APPLICATION NO.	FILING DATE	FIRST NAMED INVENTOR	ATTORNEY DOCKET NO.	CONFIRMATION NO.
10/828,617	04/21/2004	Christopher J. Scafidi	016295.1607 (DC-06227)	5833

Office Action Summary	Application No. 10/828,617	Applicant(s) SCAFIDI ET AL.	
	Examiner Felix O. Figueroa	Art Unit 2833	—

DETAILED ACTION

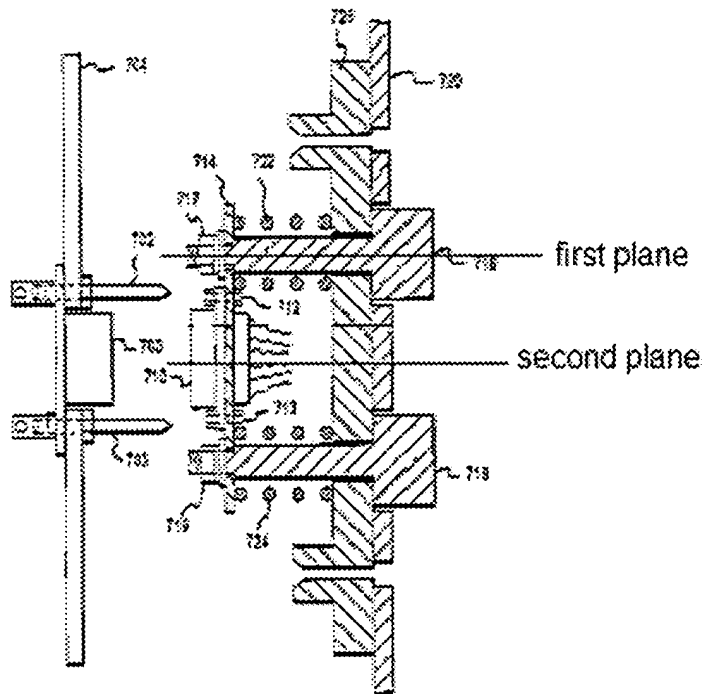
Claims 1, 4, and 7 are rejected under 35 U.S.C. 102(e) as being anticipated by Komenda et al. (US 6,592,387).

Komenda discloses a spring-loaded assembly for coupling a connector (710) to a computer component comprising: an assembly housing (720,726) operable to receive a portion of a screw (716) used to couple the connector to a chassis (720,726) of an information handling system, so that the assembly housing is located in a first plane and the connector is located in a second plane (see following figure), the first plane offset from and generally parallel to the second plane (see following figure); a sliding block (714) disposed in the assembly housing and operably engaged with the screw, the sliding block operable to linearly translate the connector between a first position and a second position within the second plane; and a spring (722) placed between the sliding block and at least one wall of the assembly housing, the spring disposed within the first plane and operable to provide an axial force to bias the connector towards the first position, whereby coupling the connector to the computer component causes the

connector to move to a connected position intermediate the first position and the second position.

In response to Applicant's argument that Komenda does not disclose "the positioning of the 1) assembly housing, 2) sliding block, and 3) spring elements in a first plane that is "offset from and generally parallel to the second plane" in which "the connector is located", please refer to the figure shown in the discussion of claim 1 (over Komenda) in which such positioning is shown.

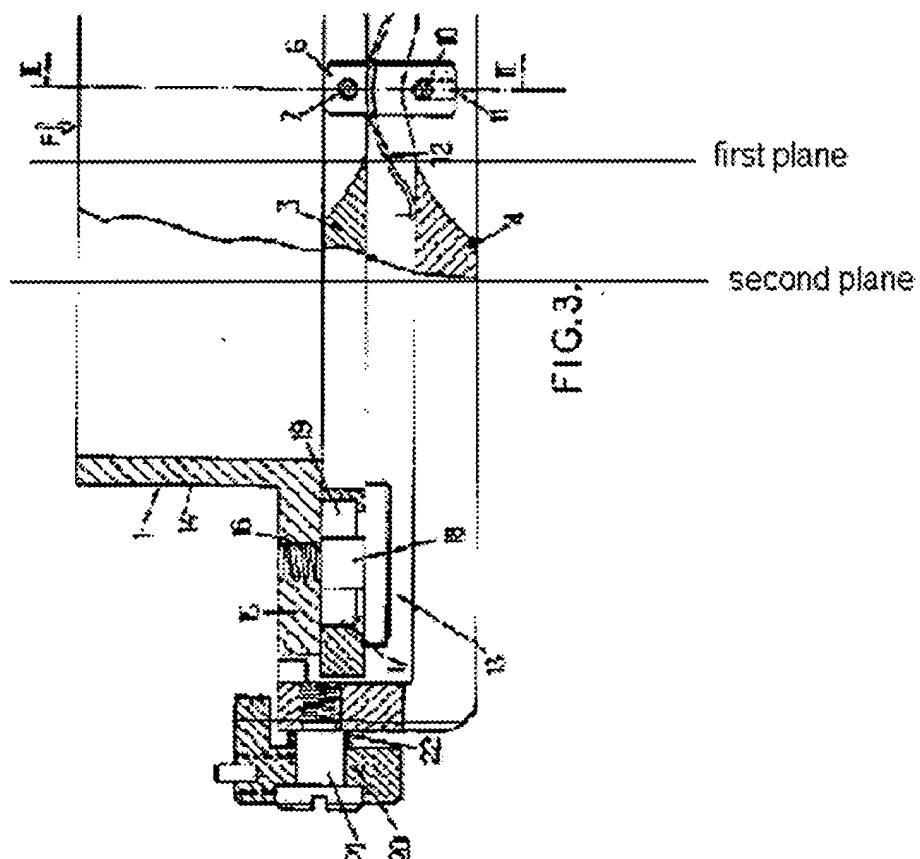
Villiers discloses a spring-loaded assembly for coupling a connector (1) to a computer component comprising: an assembly housing (4) operable to receive a portion of a screw (18) used to couple the connector to a chassis (by 2) of an information handling system, so that the assembly housing is located in a first plane and the

connector is located in a second plane (see following Figure), the first plane offset from and generally parallel to the second plane (see following figure); a sliding block (3) disposed in the assembly housing and operably engaged with the screw, the sliding block operable to move the connector between a first position and a second position; and a spring (12) placed between the sliding block and at least one wall of the assembly housing, the spring operable provides an axial force to bias the connector to a first position, whereby coupling the connector to the computer component causes the connector to move to a connected position intermediate the first and second position.

Regarding claim 2, Villiers discloses an extension member (6) coupled to and extending from the block, the extension member operable to guide the movement of the spring.

Regarding claim 3, Villiers discloses an end stop (at 11) coupled to the assembly wall adjacent the spring, the end stop operable to interact with the extension member to fix the position of the second position.

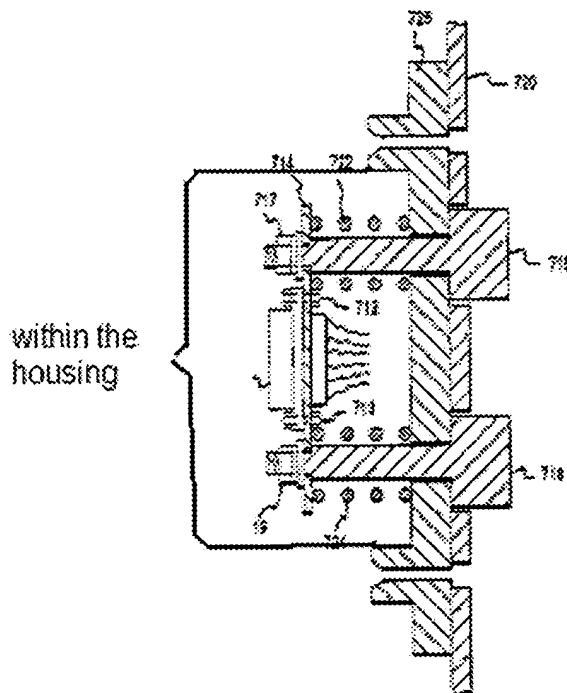
In response to Applicant's argument that the mounting plate is not housed within elements 720 and 726, please note that at least when the mounted plate is pushed backwards (right in Fig. 7) the mounting plate is within the housing (see following figure).
